# Access Compliance Report

## Public Rights-of-Way

Intersection ID: 43145	Main Street: E_INDEPENDENCE_BV	Cross Street: E_INDEPENDENCE/BRIAR_CREEK_RA	Location: SW
ADA ID: 9F3965908E62	Ramp Type: Perp	Initial Pass/Fail: Fail	Overall Compliance: No
Severity Score: 8.75			
Codes/Mitigation Info/Possible Solution		Field Measurements/Component Compliance

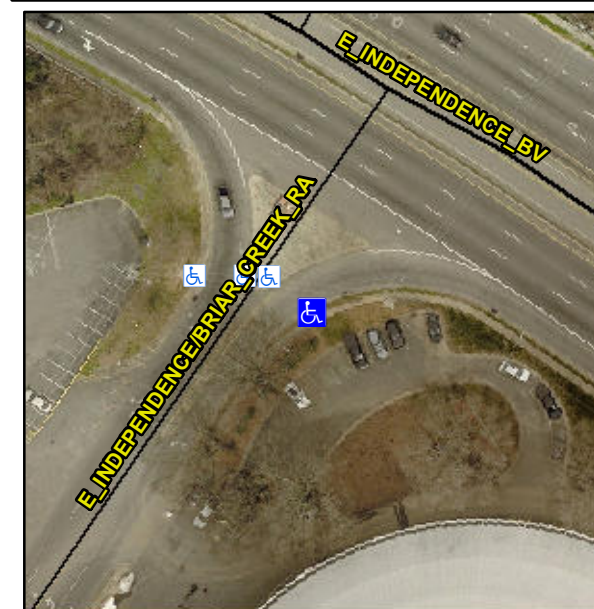
**Not Found, R304.5.1**

Compliance	Description	Data	Compliance	Description	Data
N/A	Ramp Length (in)	30.0	Yes	Ramp Slope (%)	7.7
No	Ramp Width (in)	41.0	Yes	Ramp XSlope (%)	0.5
N/A	Flare Type LT	N/A	N/A	Flare Type RT	N/A
N/A	Flare Slope LT (%)	N/A	N/A	Flare Slope RT (%)	N/A
N/A	Flare Traversable LT?	N/A	N/A	Flare Traversable RT?	N/A
N/A	Landing Length (in)	N/A	N/A	DWS Provided?	N/A
N/A	Landing Width (in)	N/A	N/A	DWS Contrast?	N/A
N/A	Landing Slope (%)	N/A	N/A	DWS Length (in)	N/A
N/A	Landing X Slope (%)	N/A	N/A	DWS Full Width?	N/A
N/A	Landing Curb? (Y/N)	N/A	N/A	DWS Offset (in)	N/A
N/A	Shared Landing?	N/A			
N/A	Gutter Ponding?	N/A	N/A	Gutter Slope (%)	N/A
N/A	Gutter Lip Ht (in)	N/A	N/A	Gutter X Slope (%)	N/A
N/A	Painted X Walk1?	No	N/A	Painted X Walk2?	N/A
	X Walk 1 Direction	To N		X Walk 2 Direction	N/A
N/A	X Walk 1 Width (in)	N/A	N/A	X Walk 2 Width (in)	N/A
	X Walk 1 Slope (%)	0.8		X Walk 2 Slope (%)	N/A
	X Walk 1 X Slope (%)	0.1		X Walk 2 X Slope (%)	N/A

**Remove & Replace Entire Ramp.**
